Re: Starbucks @ Lomas & Washington

4407 Lomas Blvd NE

Grading and Drainage Plan Permanent CO – Accepted

Grading and Drainage Plan

#### Starbucks Covered Sidewalk Culvert

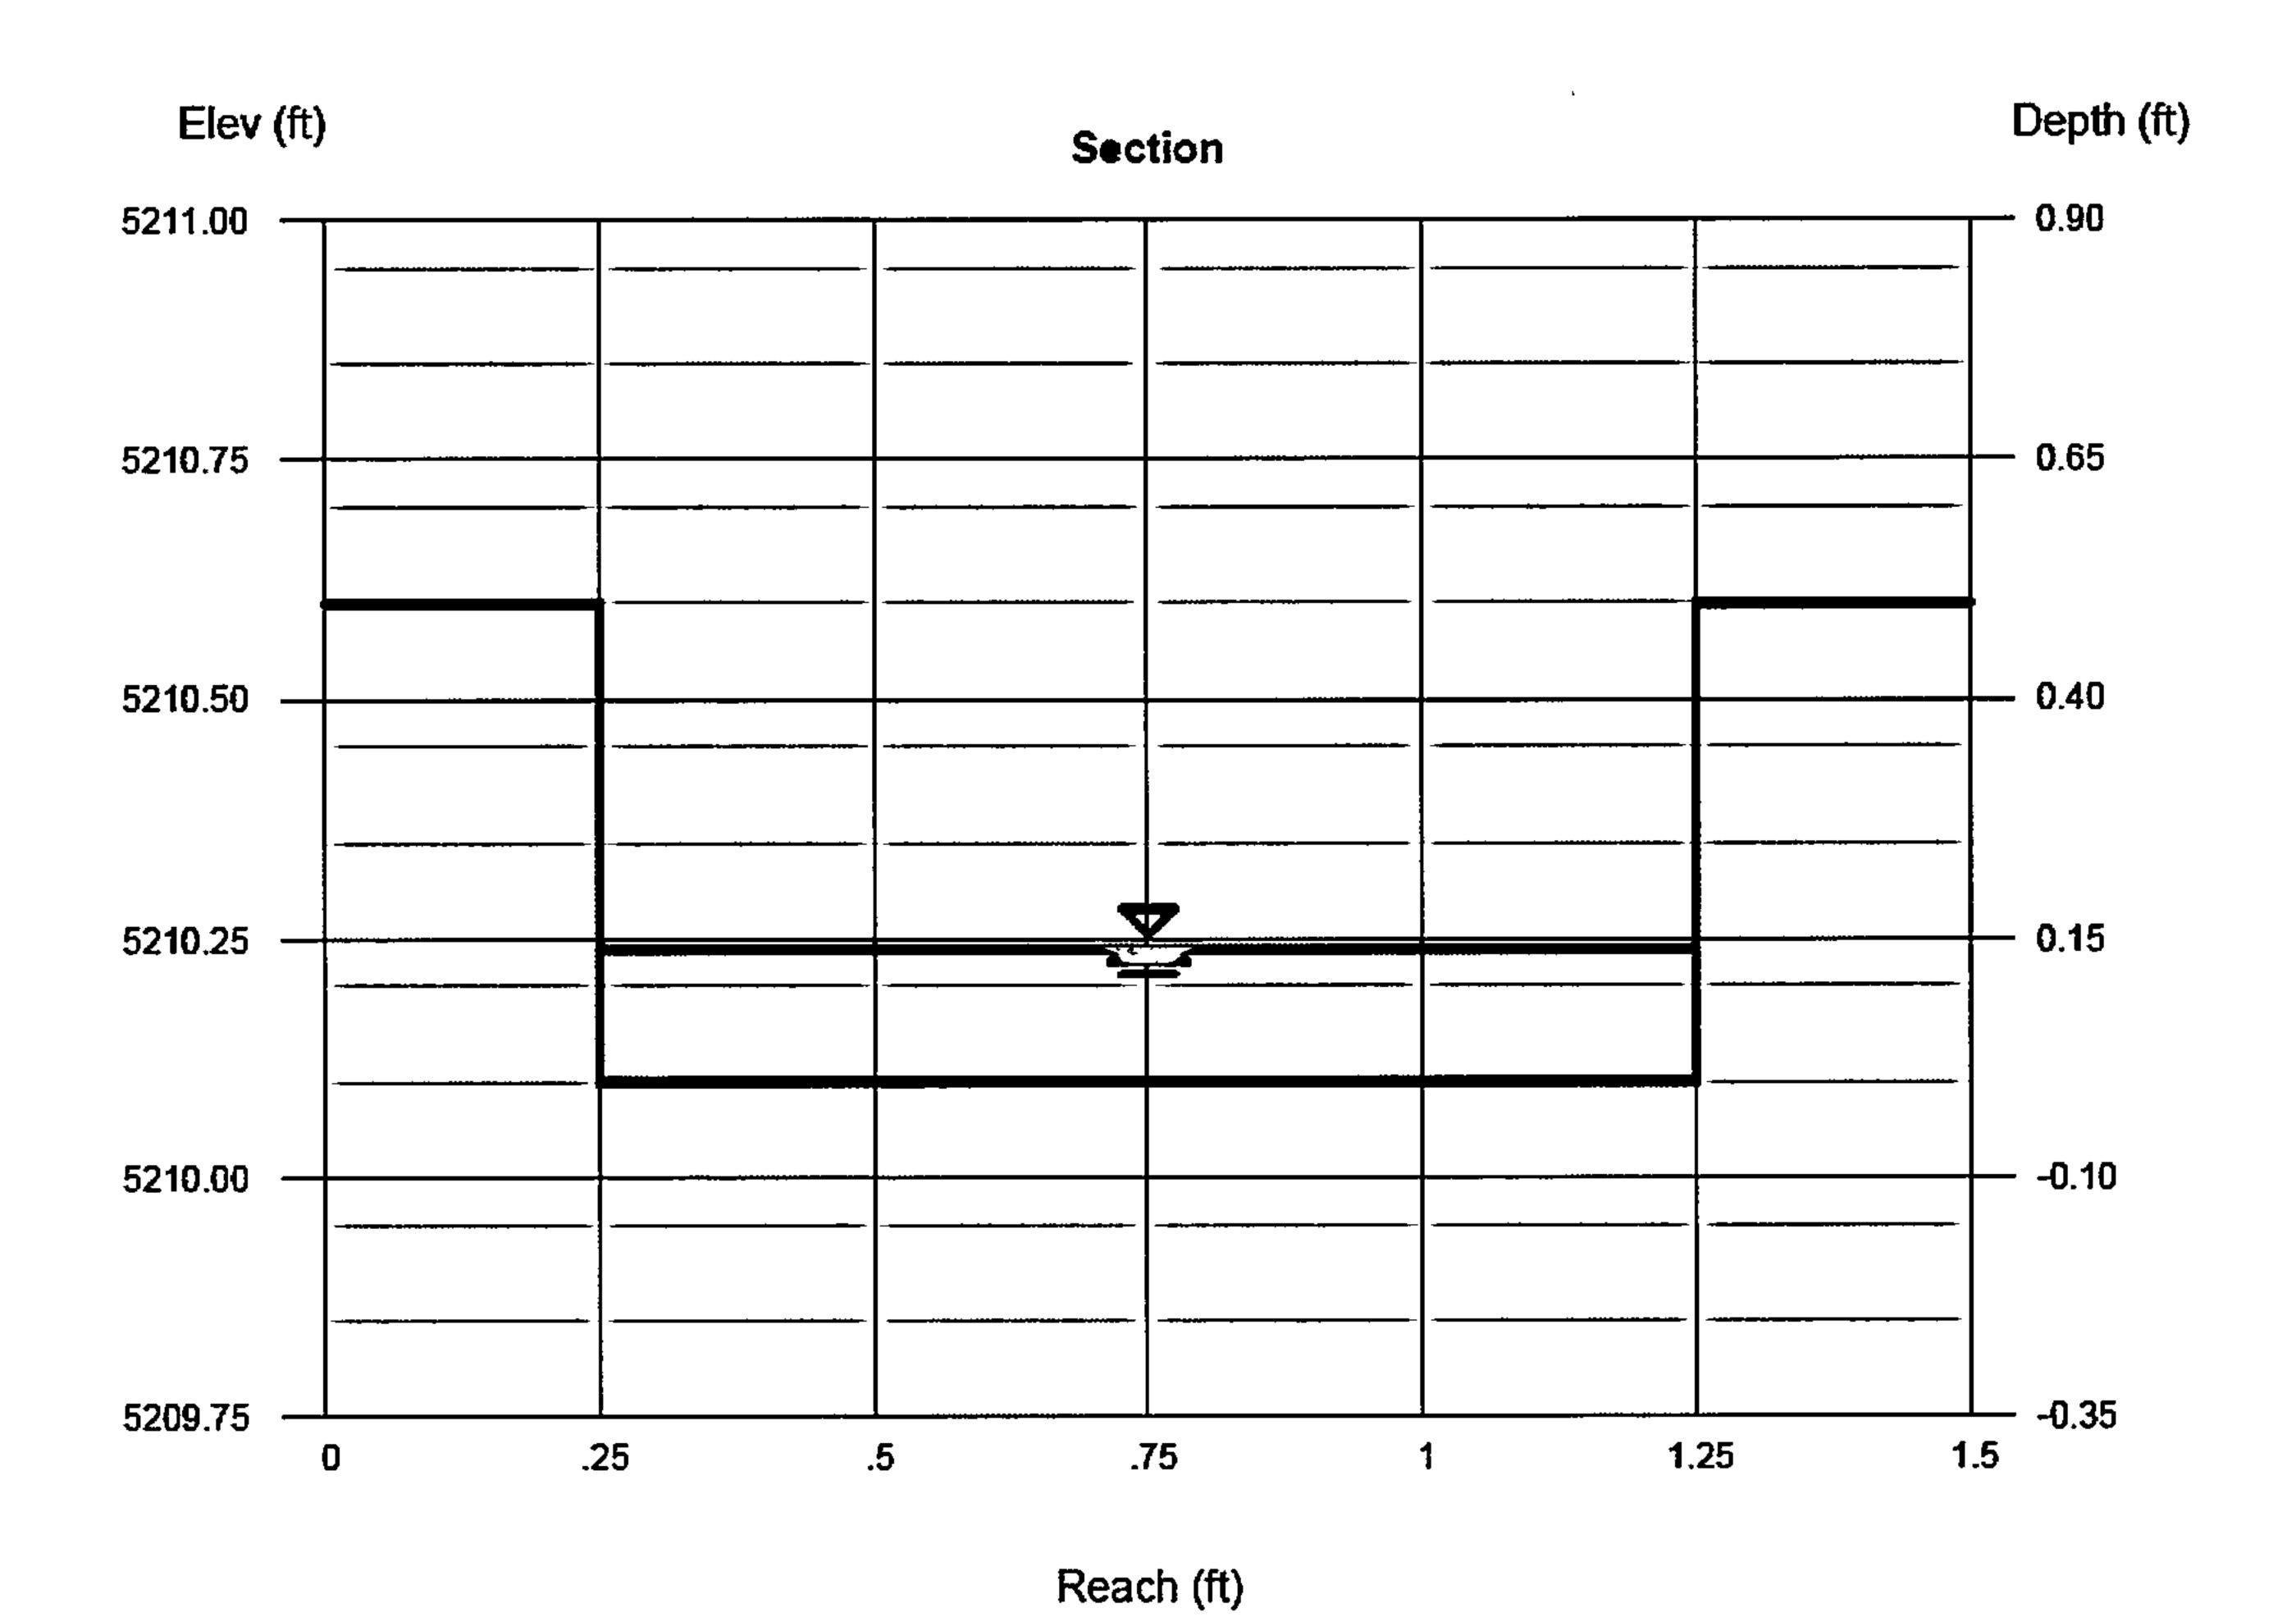
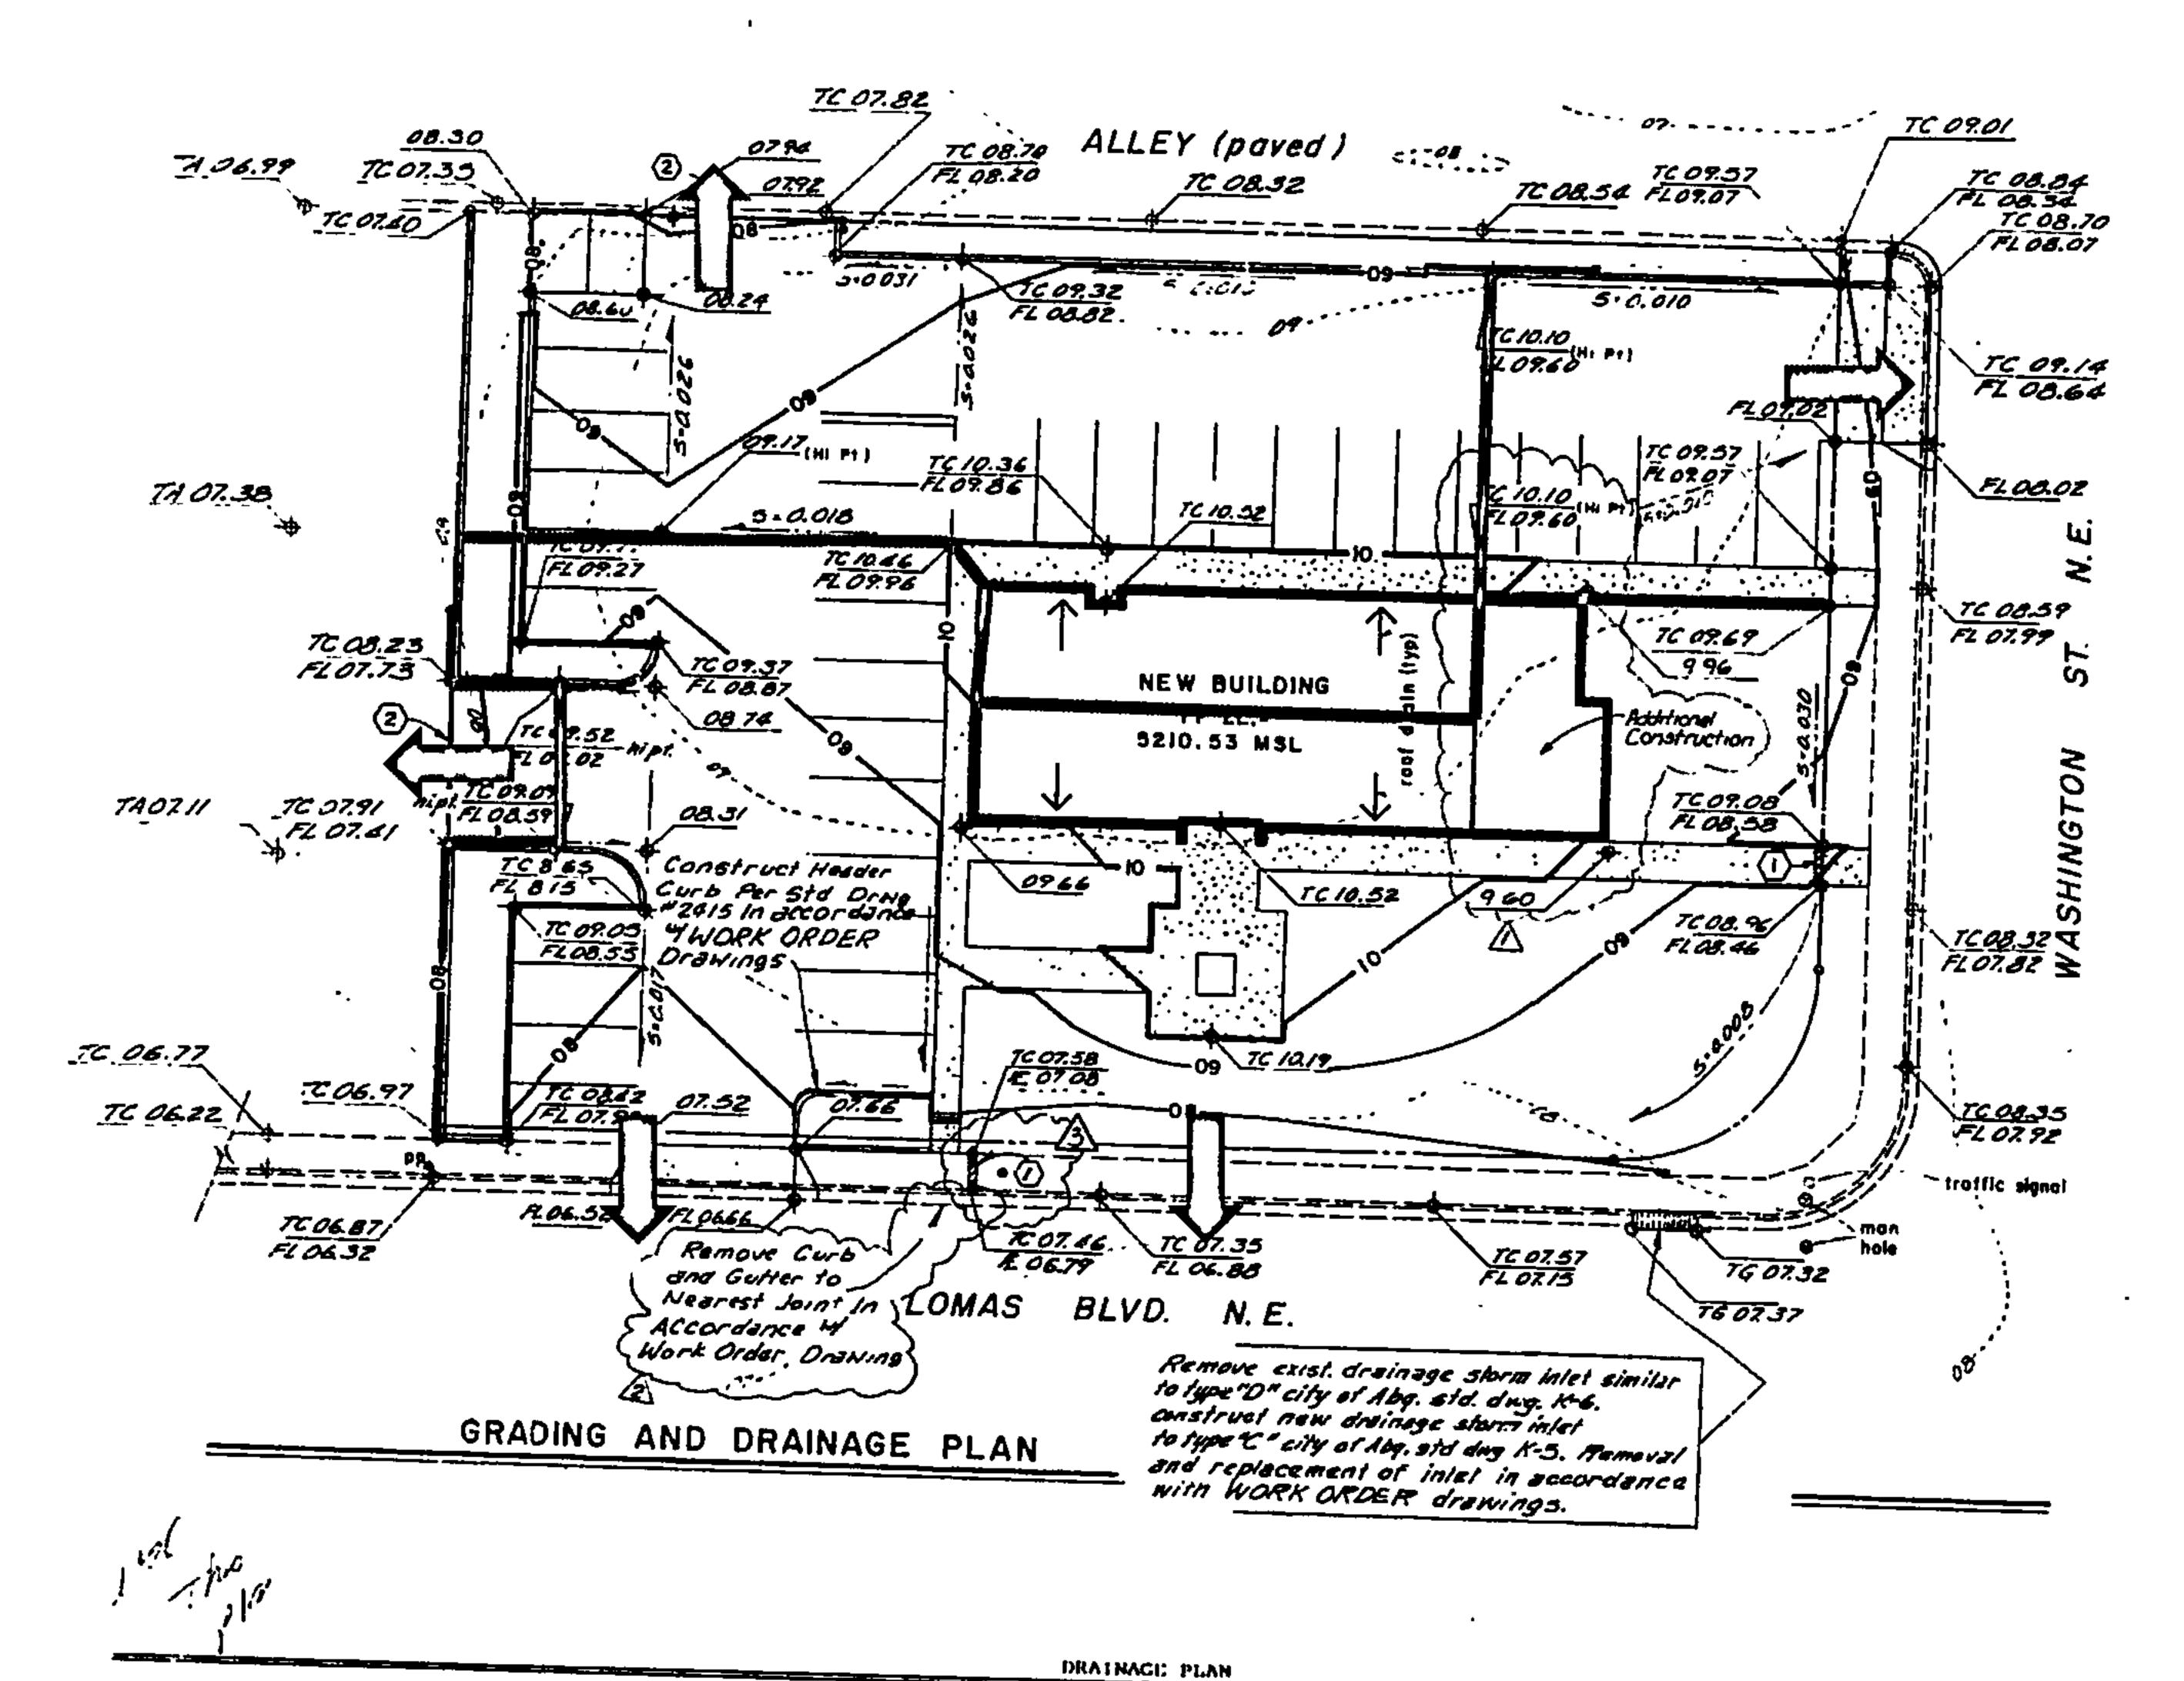
3) For each of the first flush retention ponding areas, label the volume that is being retained. Show capacity of each of the on-site sidewalk culverts and the flow that it is capturing.

12" wide x 6" high opening (either curb cut or covered sidewalk culvert) can accept 1.4 cfs max.
